ANSTEY PARK STRUCTURE PLAN

AMENDMENT No.1

SPN/0876M-1

The purpose of the amendment is to relocate the northern public open space (POS) area on Lots 35 and 36 to the southwest corner (near the intersection of Surf Drive and Warnbro Sound Avenue). As a result of the relocation of the POS, the lots adjacent to the new POS location have an increased density code from R20 to R30 with the lots adjacent to and comprising the old POS location having a density code of R20.

The structure plan applies to land generally bounded by Warnbro Sound Avenue, Anstey Road, Mandurah Road and Kimberly Drive, Secret harbour being the area outlined in the Structure Plan Map (**Plan1**).

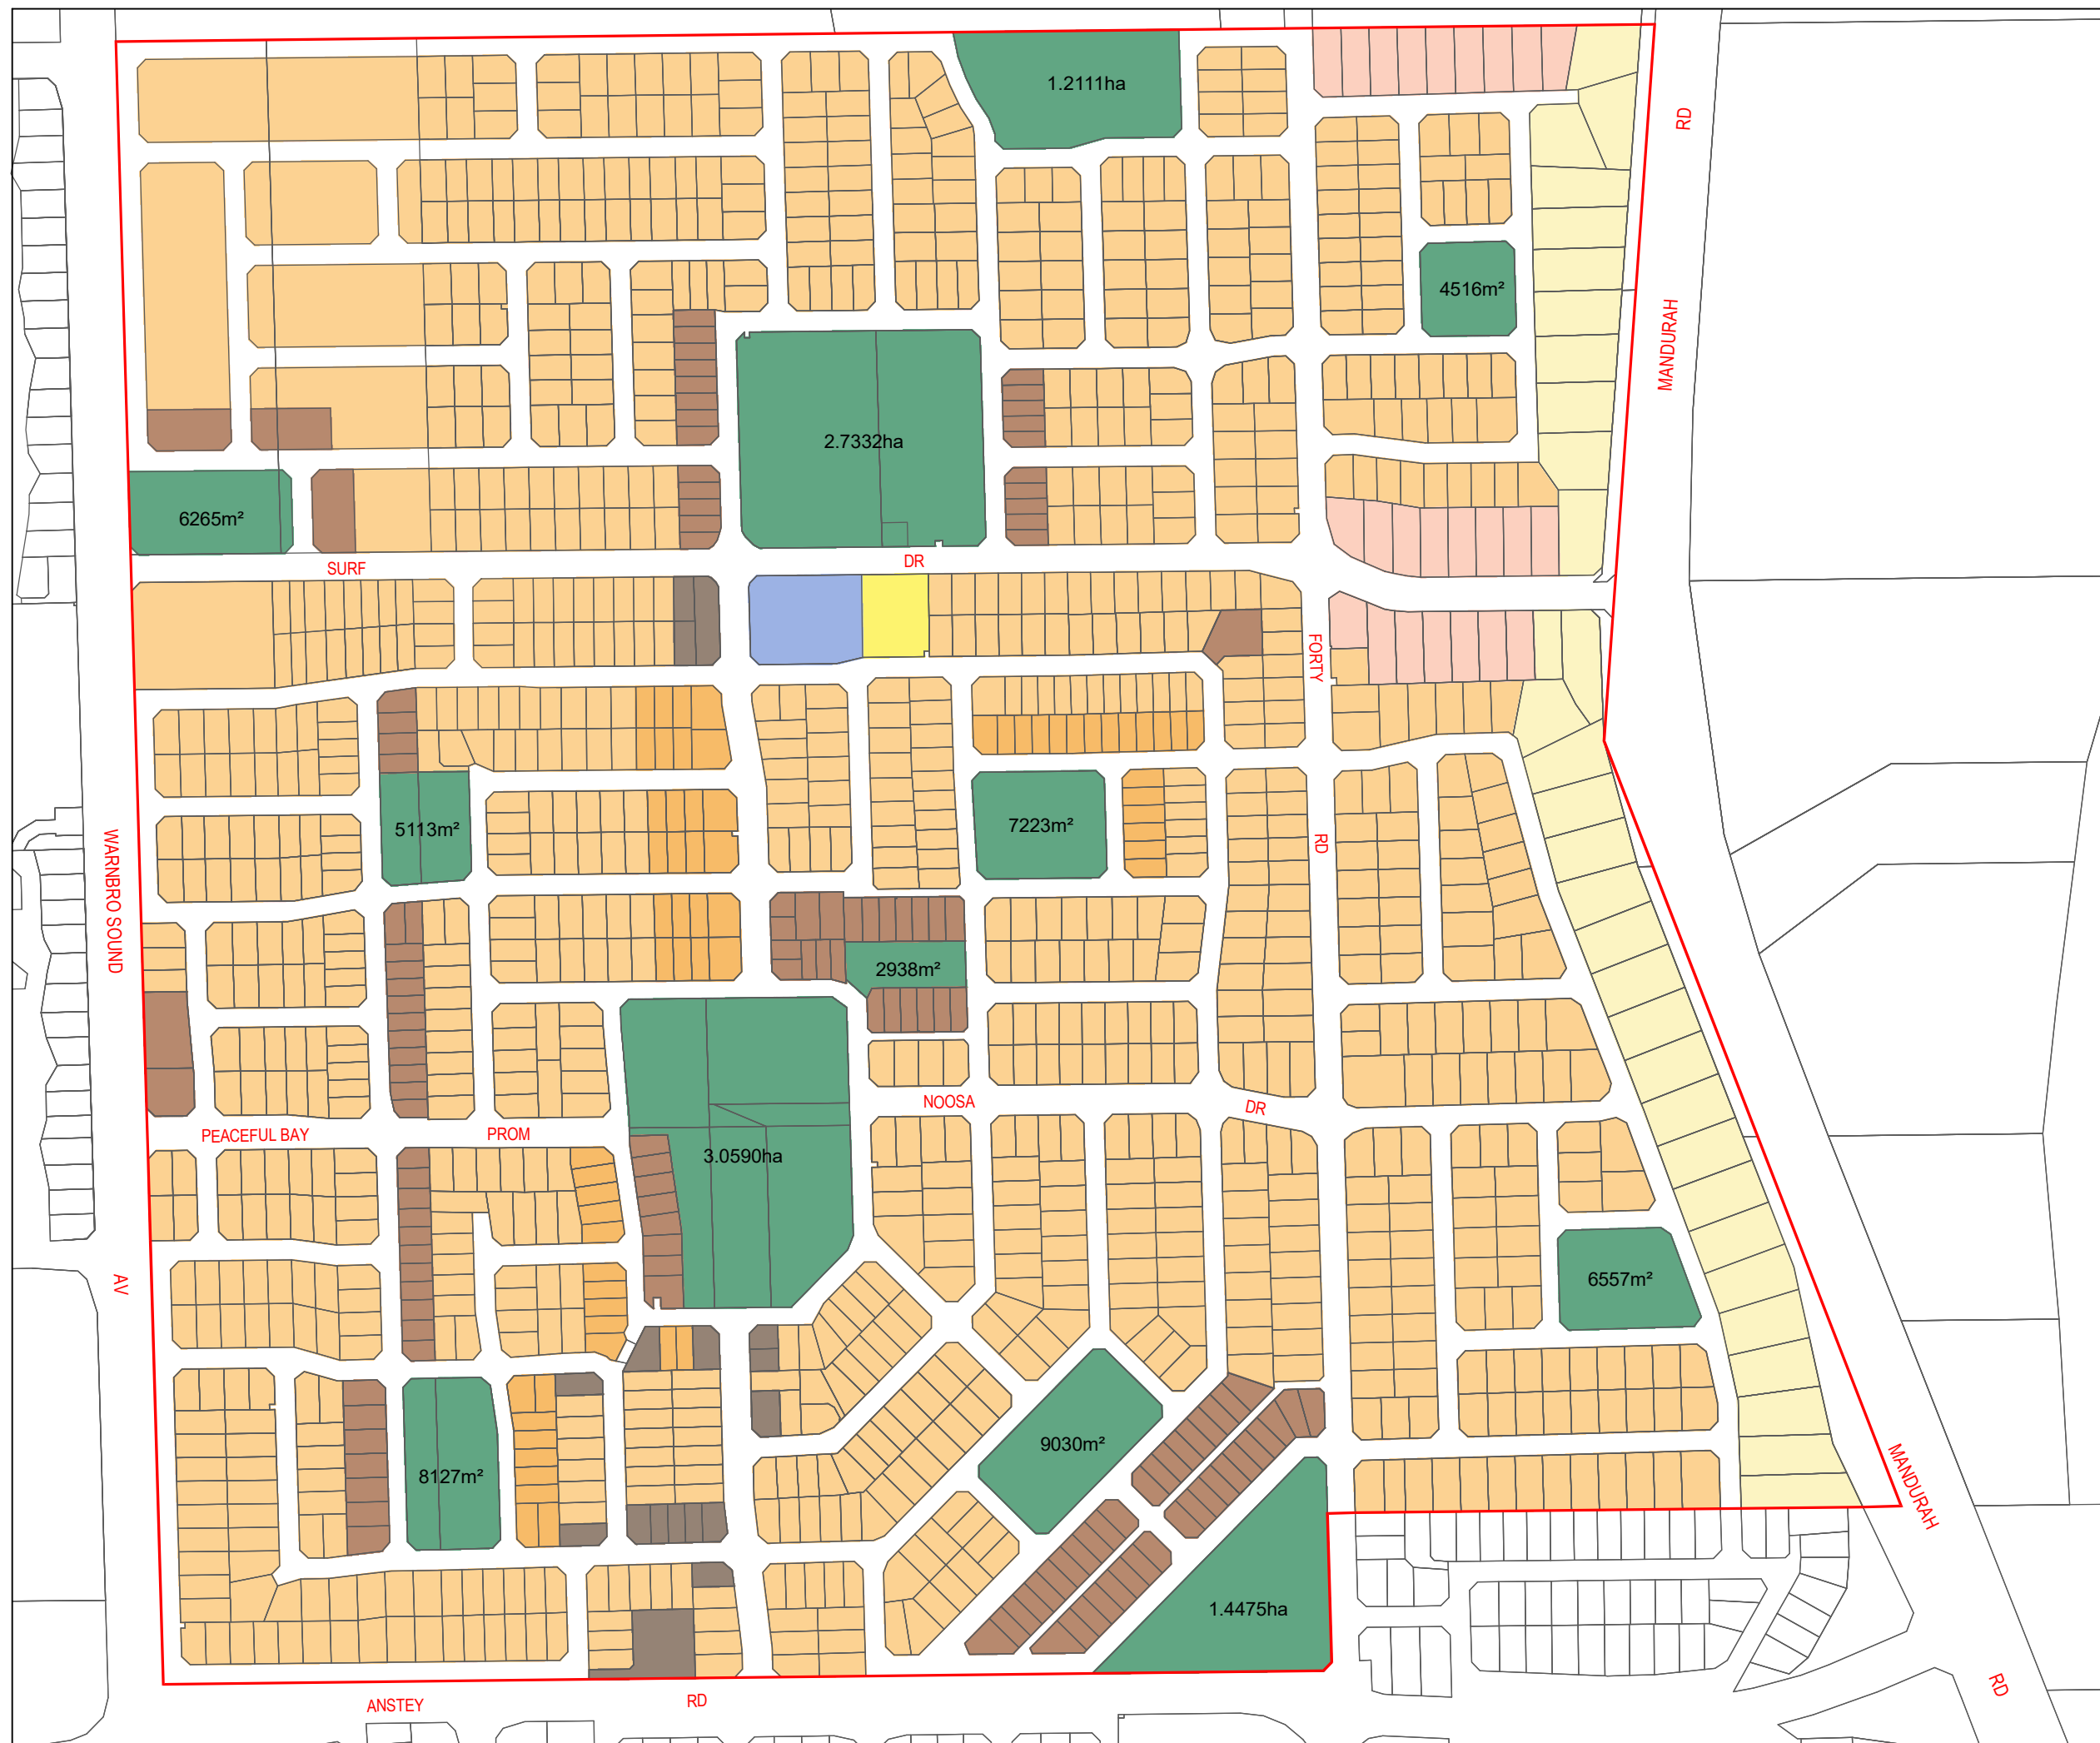
Plan 1 designates proposed zones and reserves in the Structure Plan area.

Plan 1 designates the R-Codes applicable to subdivision and development in the Structure Plan area.

Figure 2: Existing Plan for Lots 35 and 36 Surf Drive

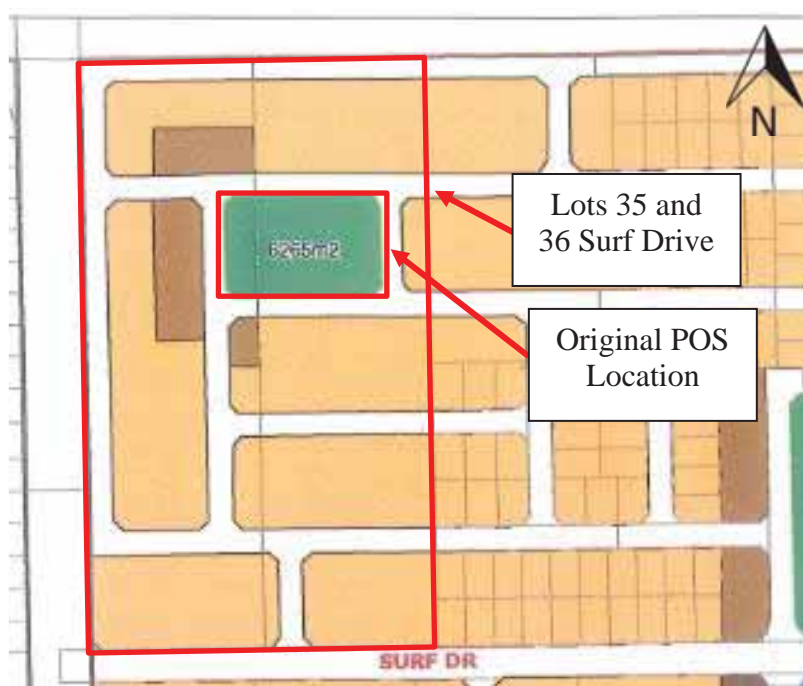
The relocation is required as the current location of the POS is on the highest point of the site which will require significant earthworks. The current location is not practical due to the required earthworks and a drainage network discharging into the stormwater basin contained within the POS. Amending the location will greatly reduce the volume of earthworks and tie-into the area with the surrounding road network.

Revised planning for the subdivision of Lots 35 and 36 Surf Drive has commenced, with a review of the proposed location of the POS. It is proposed to move the location of the Public Open Space from the original location shown in Figure 2 to the proposed location shown in Figure 3.
